## LITEON would like to Change Package Design from 1BE to 1DE

# Product Change Notice

Product Group: Lamp product/ Aug.20.2021 / PCN-210820-01\_Rev 1

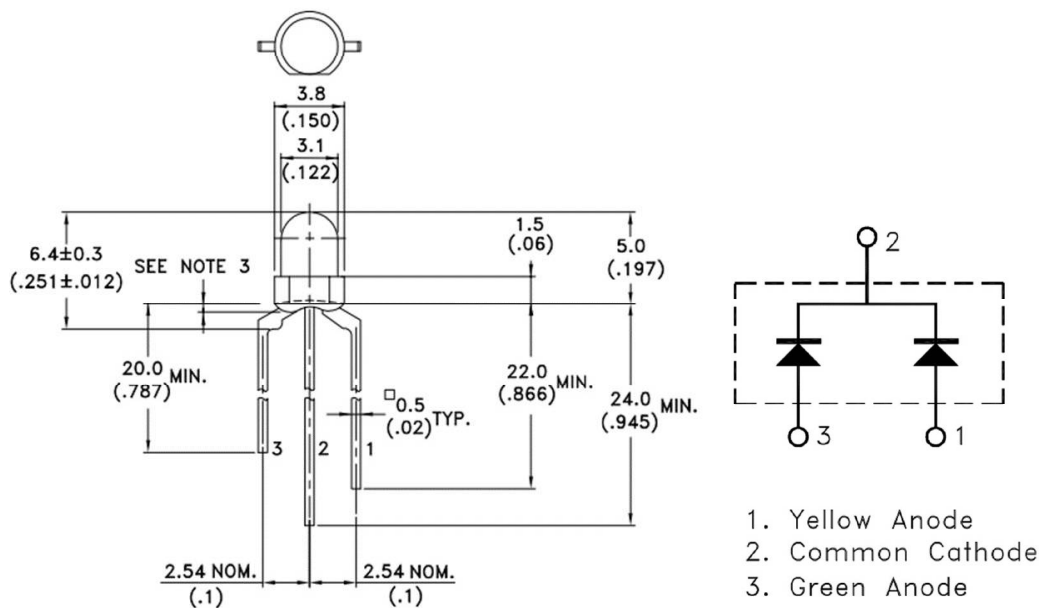
LITEON-OPTO TH lamp product: Design of 1BE package will be changed to design of 1DE package. Please see detail information in below table.

Current Design	New Design
Series Name	1BE Lamp	1DE Lamp
Outline Dimension		
Optical & Electrical	<b>Keep same specification</b>	
Flange Cutting Edge

To enhance the strength of package mechanism structure:

1. Flange Cutting Edge: As above drawing
2. Flange Thickness: 1.0mm → 1.5mm
3. Main Body Diameter: 3.0mm → 3.1mm
